**METROPOLITAN GOVERNMENT OF NASHVILLE AND DAVIDSON COUNTY**

**STAFF RECOMMENDATION**

**1419 Calvin Avenue  
November 19, 2014**

**Application:** New construction – infill and detached accessory dwelling unit  
**District:** Lockeland Springs-East End Neighborhood Conservation Zoning Overlay  
**Council District:** 06  
**Map and Parcel Number:**  
**Applicant:** Mark Chesnut, Chesnut Enterprises  
**Project Lead:** Sean Alexander, sean.alexander@nashville.gov

FRONT ELEVATION  
SCALE: 1/4" = 1'-0"

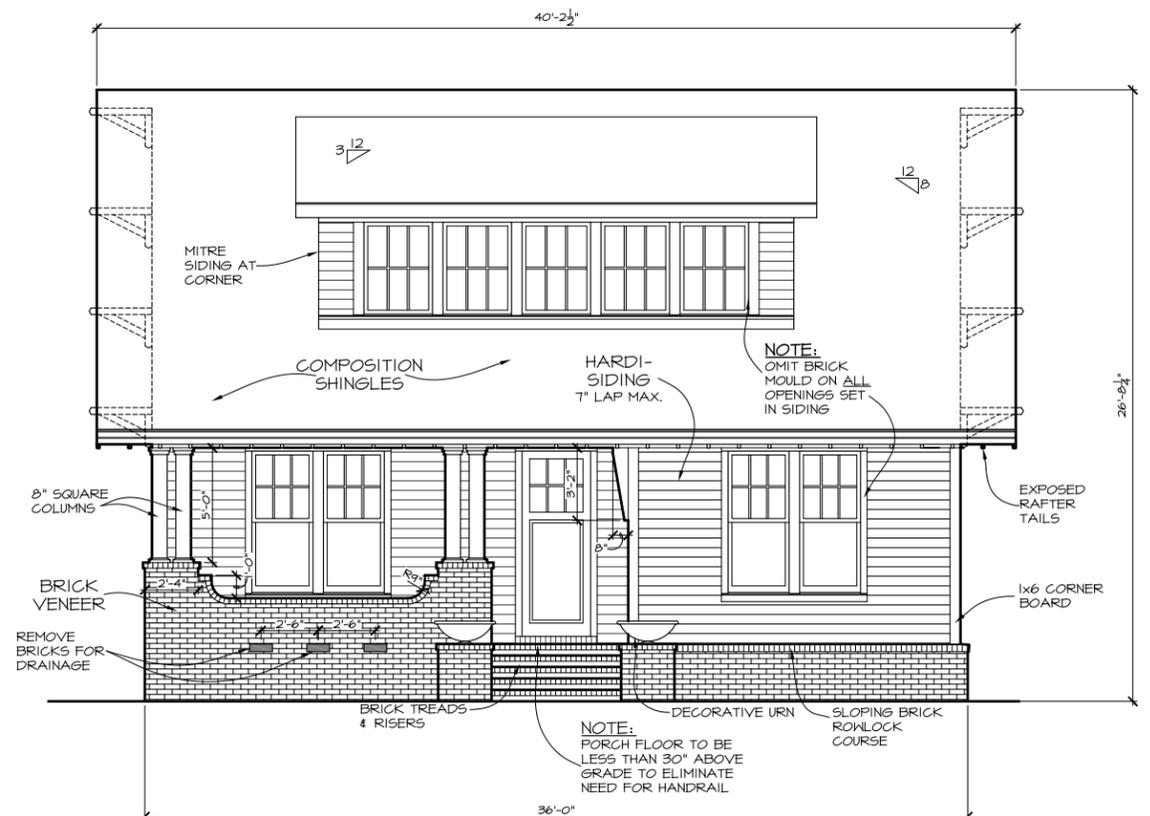
**Materials:** The new house will primarily be clad in smooth face cement fiberboard with a reveal of five inches (5"). The trim will be wood. The foundation and a right side chimney will be brick, and the roof will be architectural fiberglass shingles. The color of the brick and roof shingles are not known. The windows will be Pella aluminum-clad windows with simulated divided lights, and the material of the doors is not known. Staff asks to approve the final door selections prior to purchase, and recommends as a condition of approval that the front door be at least fifty percent (50%) glass.

Roof form: The new house will have a side gabled roof with a pitch of 8:12. On the front slope of the roof there will be a shed dormer with a 3:12 pitch. The front dormer will sit four feet (4') back from the leading eave of the house. On the rear of the building, behind the primary side gabled component, there will be a rear facing gable with a pitch of 8:12. On each side of this gable there will be side-facing shed dormers. These outer walls of these dormers will sit directly over the side walls of the first story below. Typically, dormers are required to sit two feet (2') back from the front or side walls of the story below. With a condition that these dormers sit back at least two feet (2'), staff finds that the roofs of the new building would be compatible with those of surrounding historic houses, and that the project would meet section II.B.5.

- The dormers on the detached accessory dwelling unit sit at least two feet (2') back from the first story walls;
- The side-facing dormers on the house sit at least two feet (2') back from the first story walls;
- The detached accessory dwelling unit is separated from the principal building by at least twenty feet (20');
- A restrictive covenant on the detached accessory dwelling unit is filed prior to issuance of the permit;
- Staff reviews and approves the final selection of windows and doors, with the front door being at least fifty percent (50%) glass; and,
- Staff approves the color of the roof and the color, dimensions and texture of the brick.

REAR GARAGE ELEVATION  
SCALE: 1/4" = 1'-0"

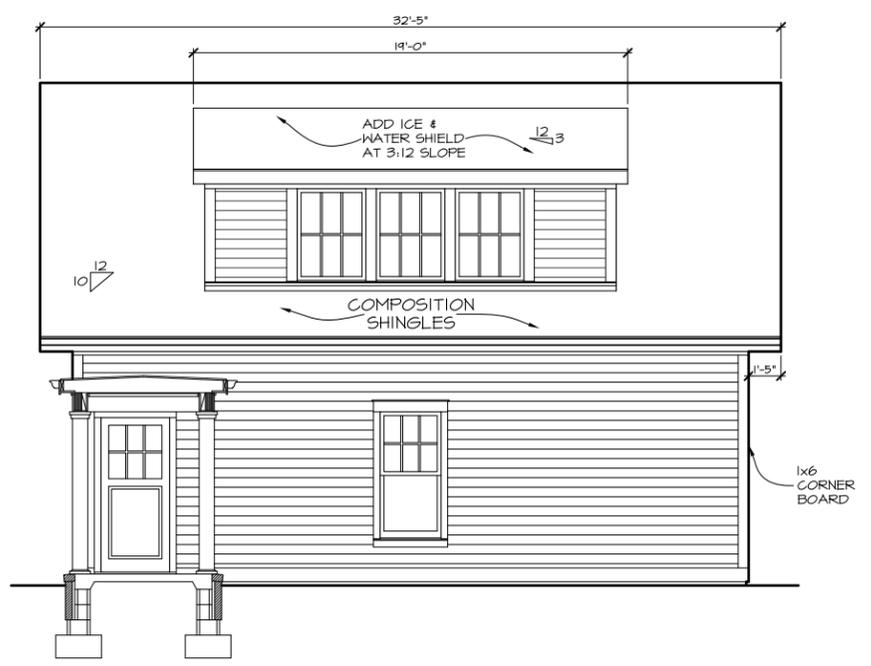
The roof of the proposed outbuilding would be a side-oriented gable, with a pitch of 10:12. This matches the form of the roof on the house, but with a slightly steeper pitch. Both slopes of the roof would have shed-roofed dormers with a 3:12 pitch. Because the building meets the definition of a detached accessory dwelling unit, the Zoning Code requires that dormers comprise no more than fifty percent (50%) of the roof plane and that they sit at least two feet (2') back from a first story wall. The proposed dormers would cover only forty-one percent (41%) of the roof planes, but the walls at the face of the dormers would stack directly over the walls of the first story. With a condition that the dormers sit back at least two feet (2'), Staff finds that the roof of the proposed outbuilding would meet guideline II.B.8.a.

Location: The design guidelines require that outbuildings be located in the established rear yard behind the principal building, and be at least twenty feet (20') from the principal building. The proposed outbuilding would be behind the house; however, it would only be fifteen feet (15') away from the principal building. The proposed outbuilding would not meet this guideline. Moving the building five feet (5') to the rear would meet this guideline, and result in an eight foot, six inch (8'-6") rear setback, which would be an appropriate setback for an outbuilding. The side setbacks would be six feet (6') on the left and fifteen feet (15') on the right. The side setbacks are appropriate.
